Re: 33 Bayberry Road – Site Plan for Bayberry Armonk, LLC.
Armonk, NY (100.03-1-6)

As an addendum to this letter, we attach our responses to the March 7, 2023 RPRC comments dated April 24, 2023.

We received comments from the RPRC dated March 7, 2023 and offer the following information:

SITE PLAN ALTERNATIVE A - TIERED WALLS (W/ DETAILED GRADING & TREE REMOVALS)

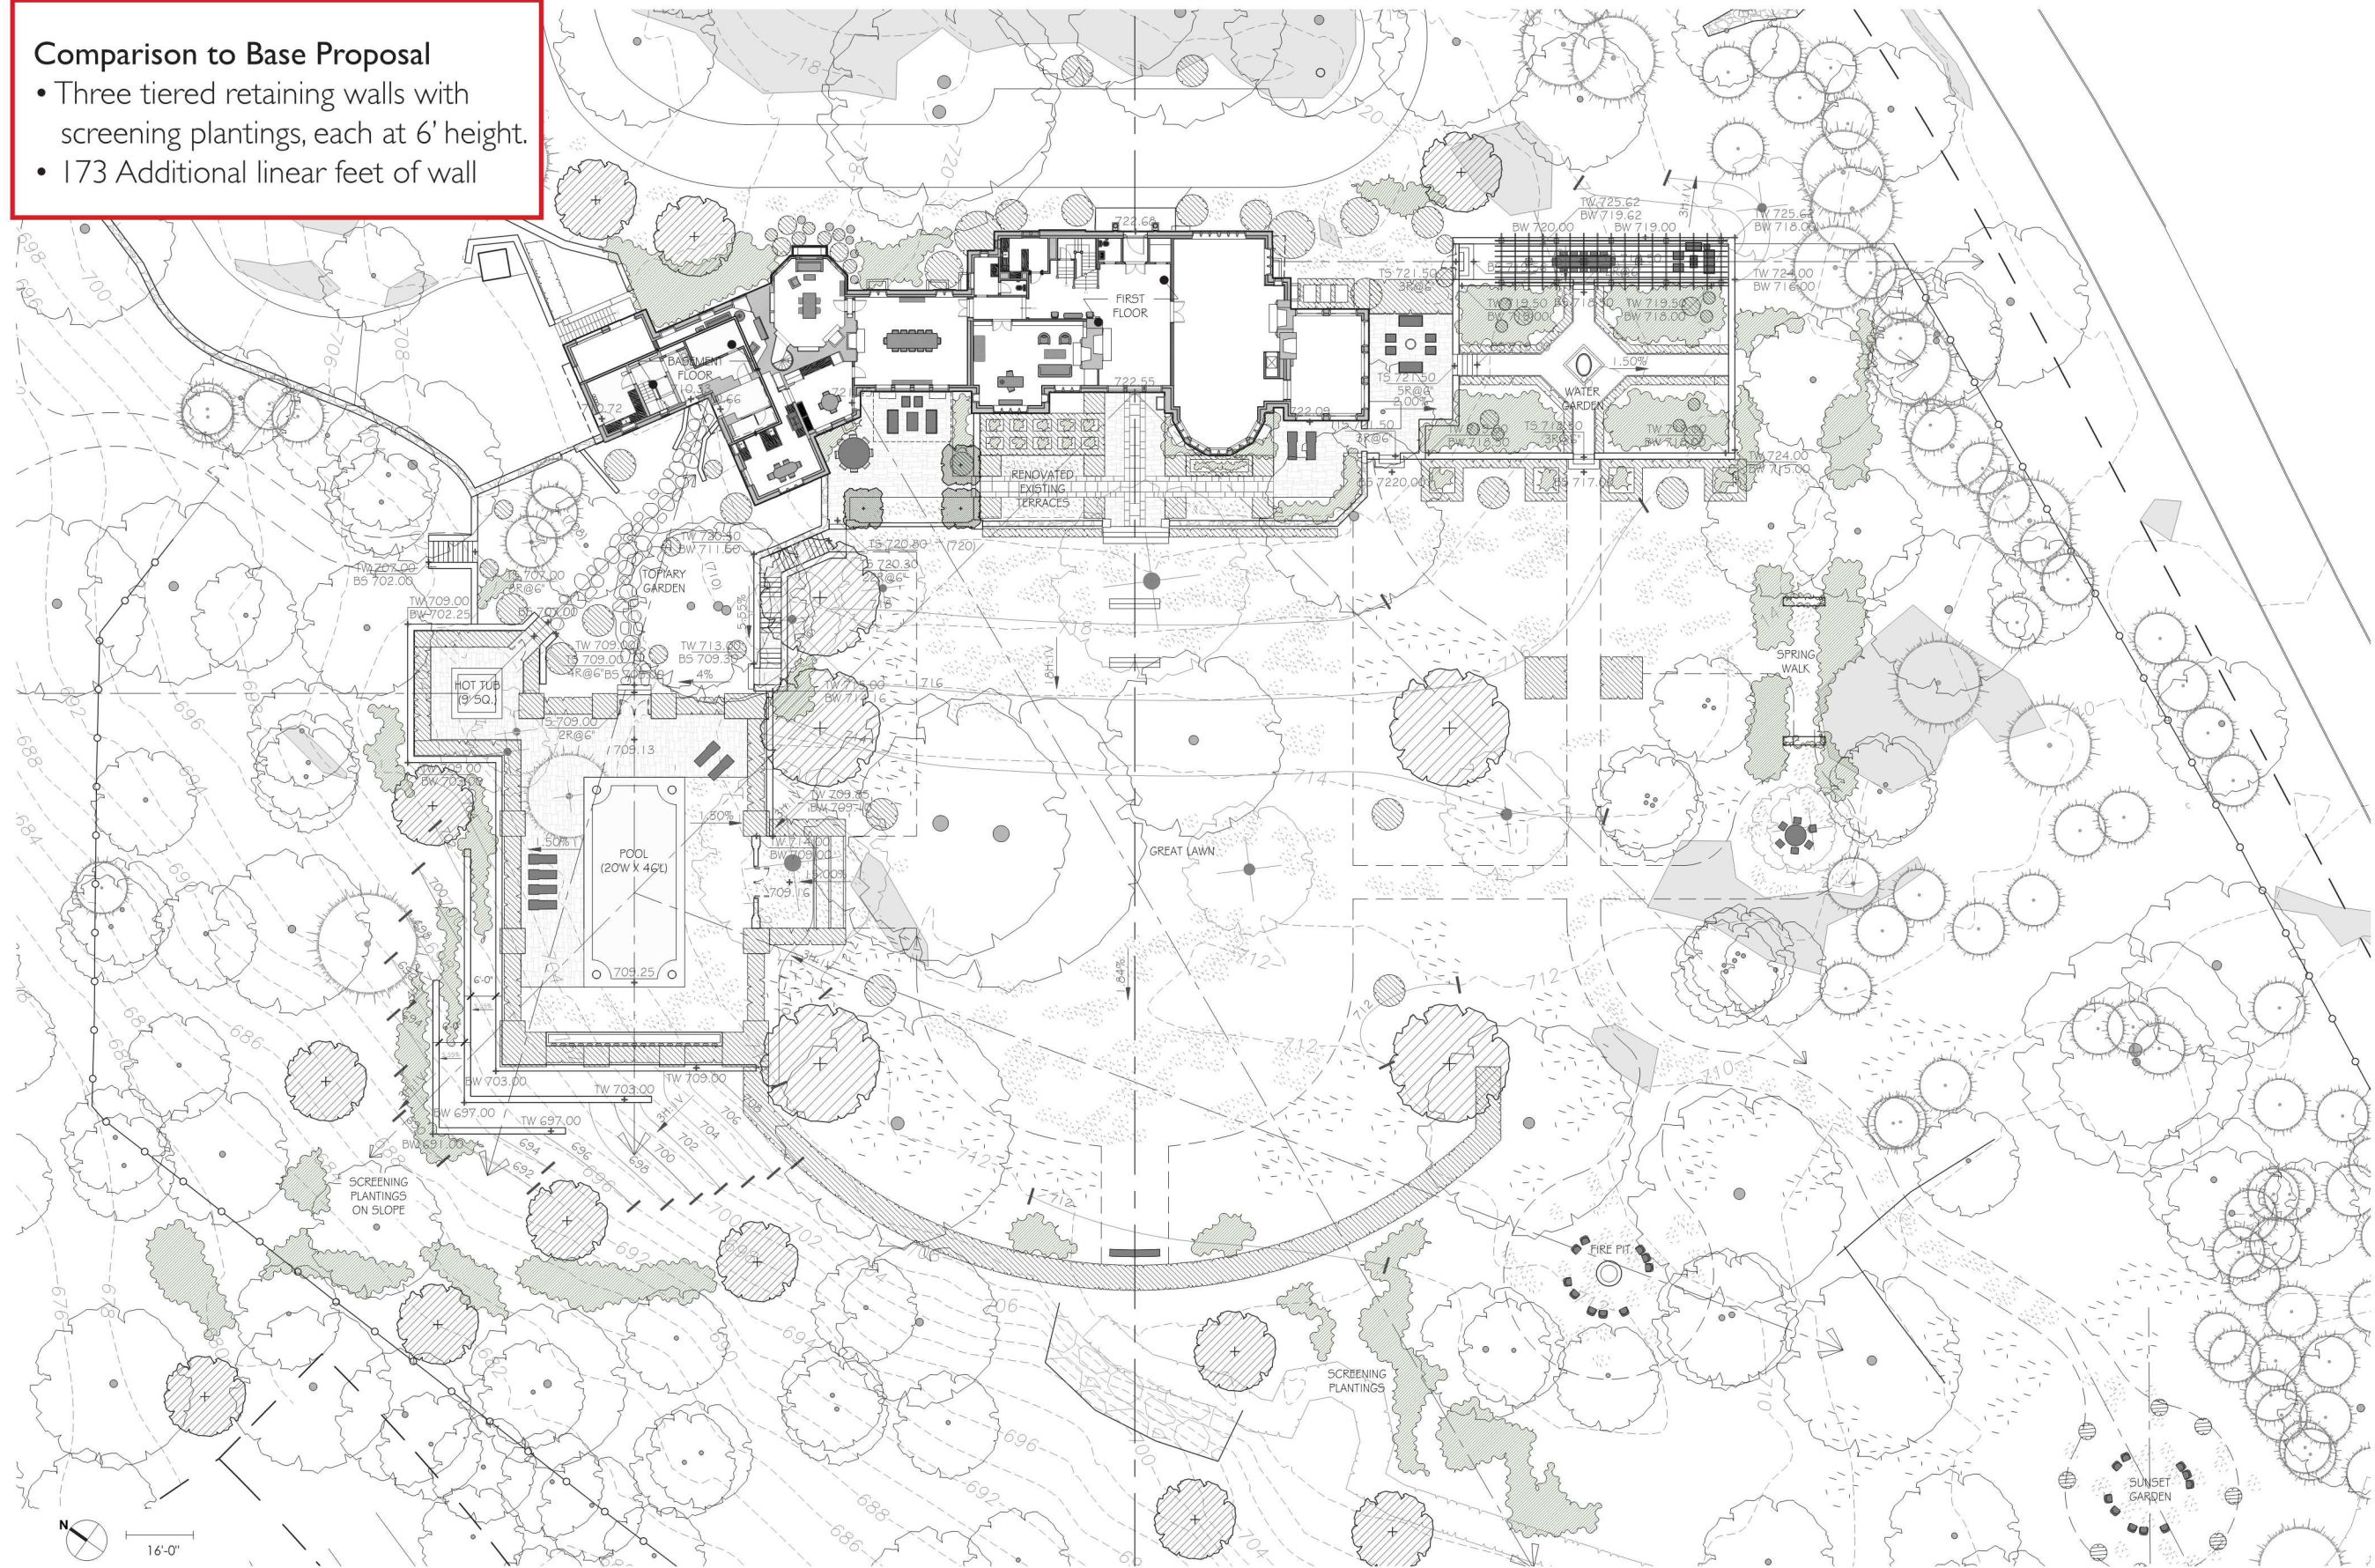
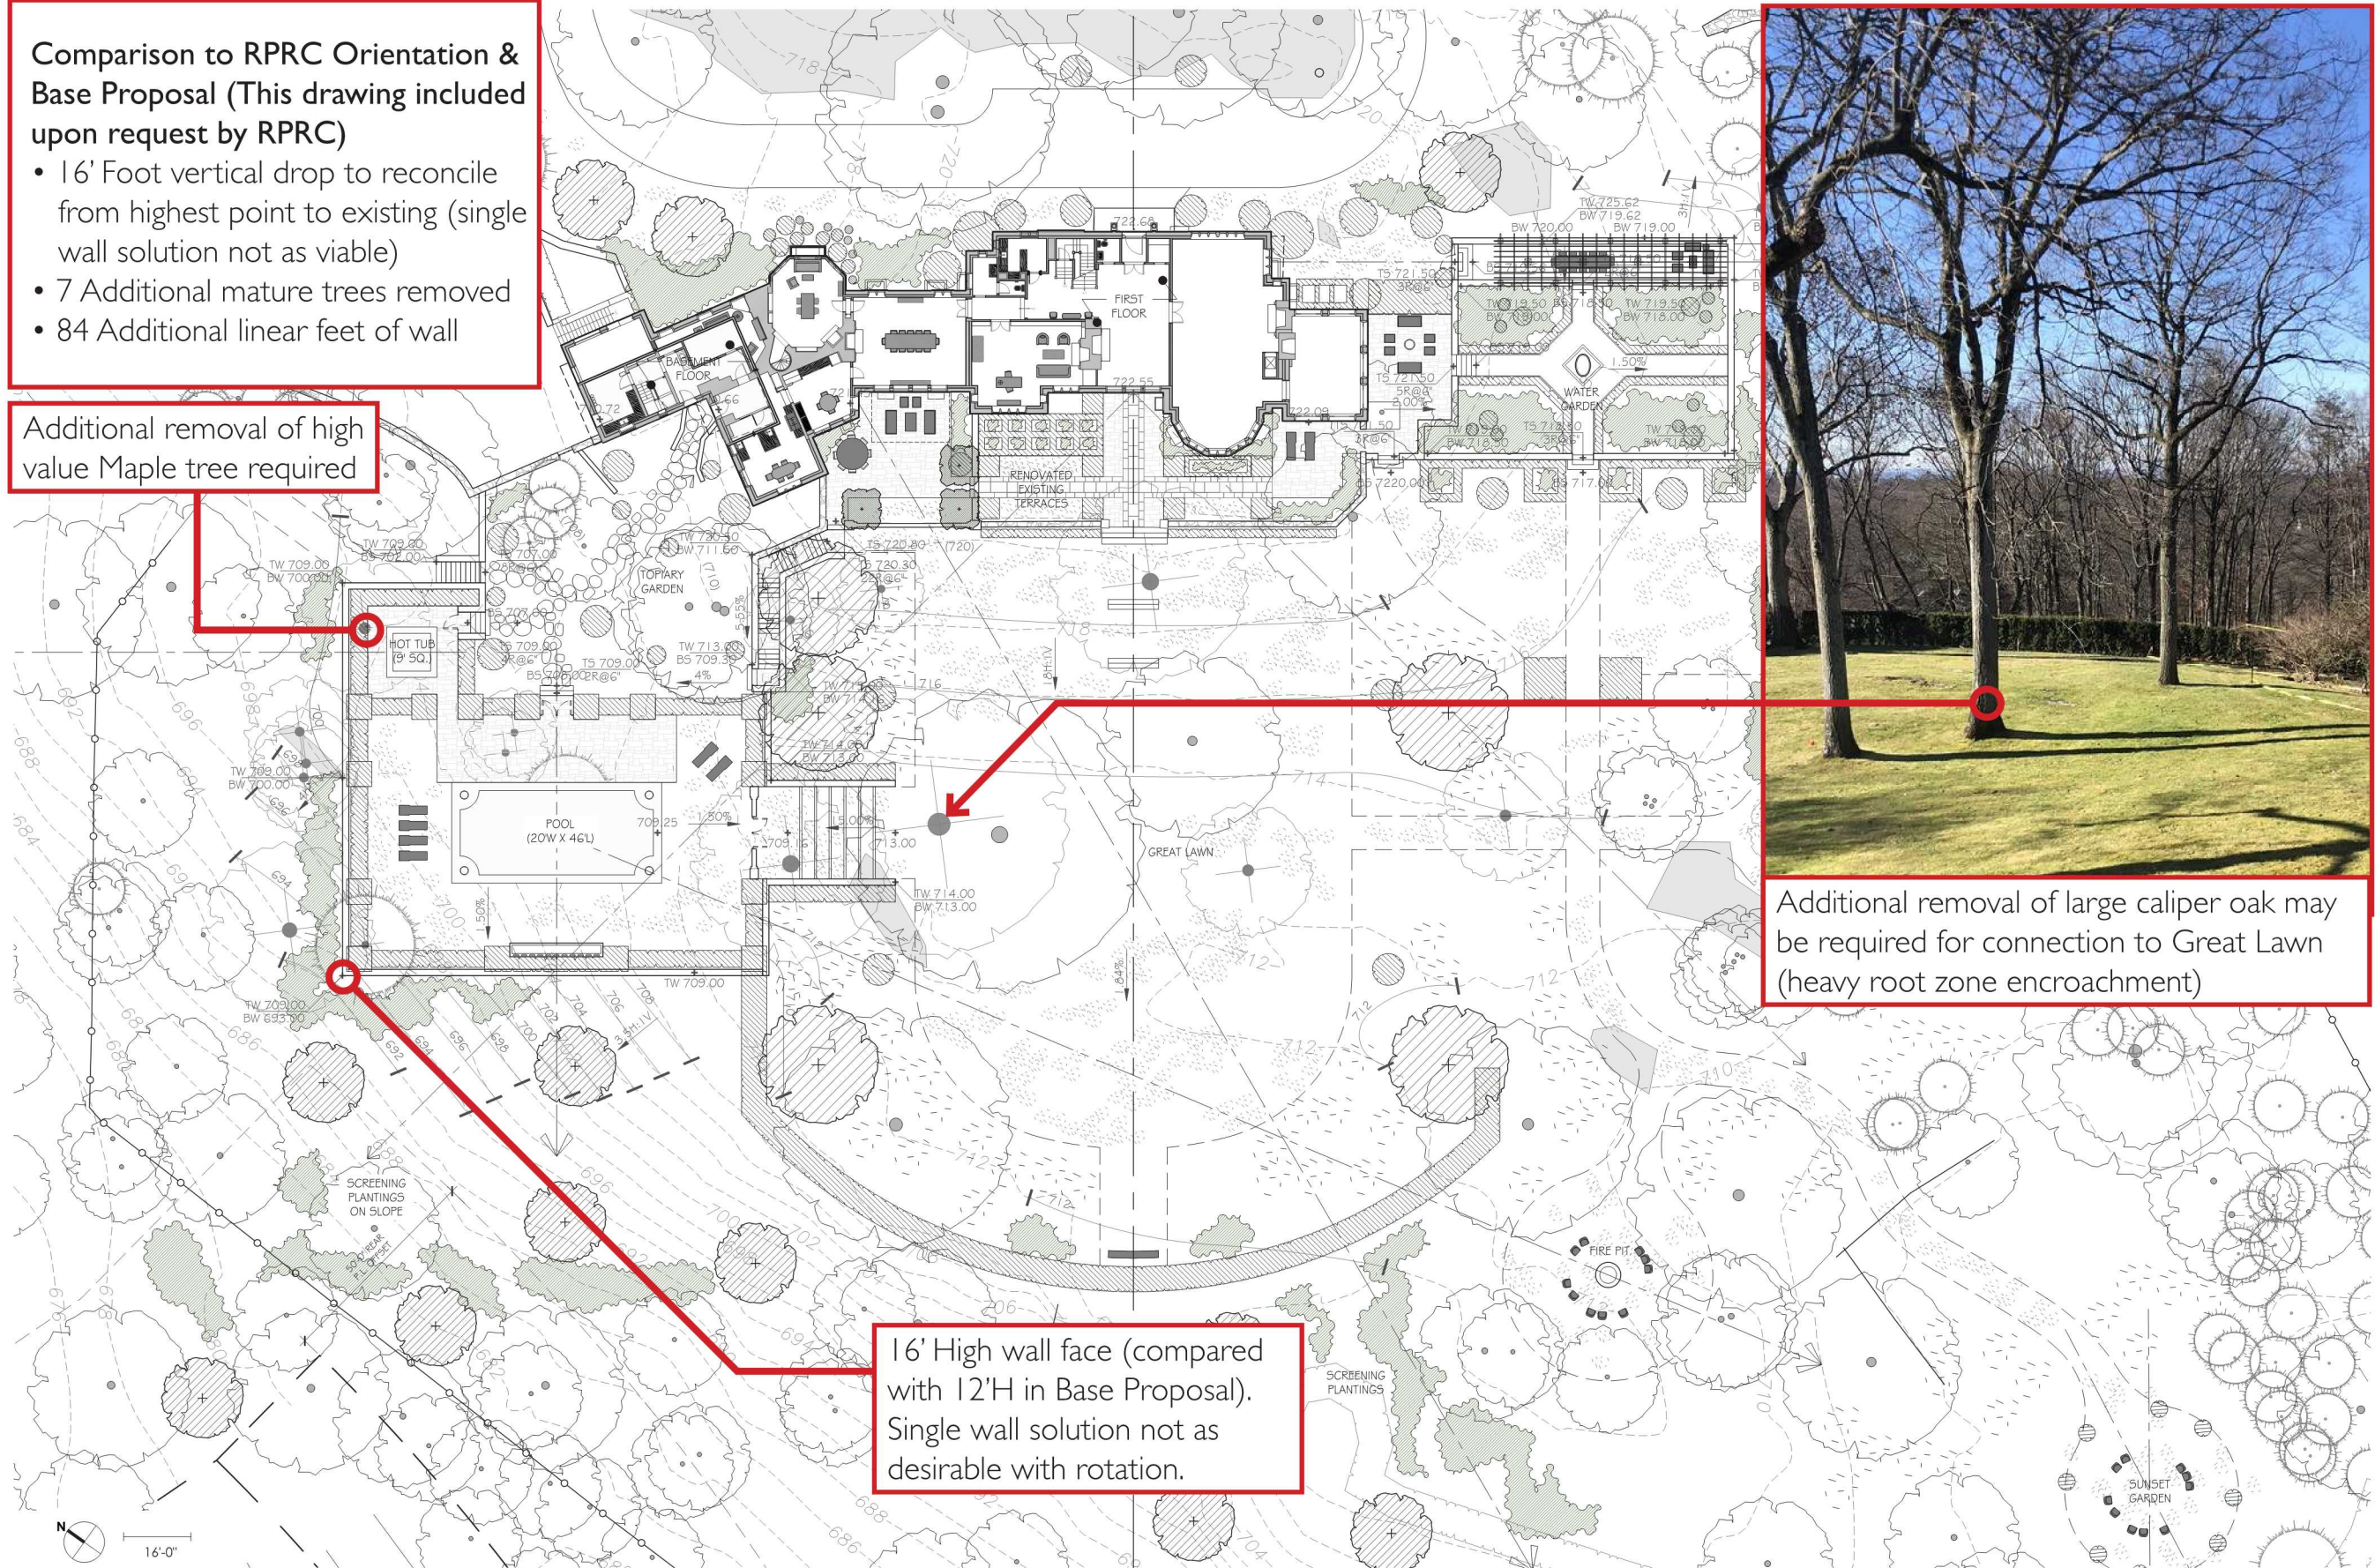
The location and orientation of the proposed pool results in a series of retaining walls. It is recommended that the pool be rotated so that grading/walls can be significantly reduced by avoiding chasing the grade down the hill.

Response: The landscaper has presented an alternate pool orientation.

- Three tiered retaining walls with screening plantings, each at 6' height.
- 173 Additional linear feet of wall

- 16' Foot vertical drop to reconcile from highest point to existing (single wall solution not as viable)
- 7 Additional mature trees removed
- 84 Additional linear feet of wall

Additional removal of high value Maple tree required
